## **Technical Service Bulletin**

14-01-041

SANTA FE SPORT

STEERING COLUMN U-JOINT NOISE FROM NOISE ISOLATION PAD (SERVICE CAMPAIGN TU3)

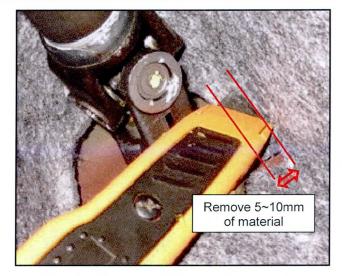
3. Using a light if needed, locate the area of contact.

4. Using a utility blade (or other desired trimming tool), remove 5~10mm of noise isolation pad material from the area of contact to eliminate the noise.
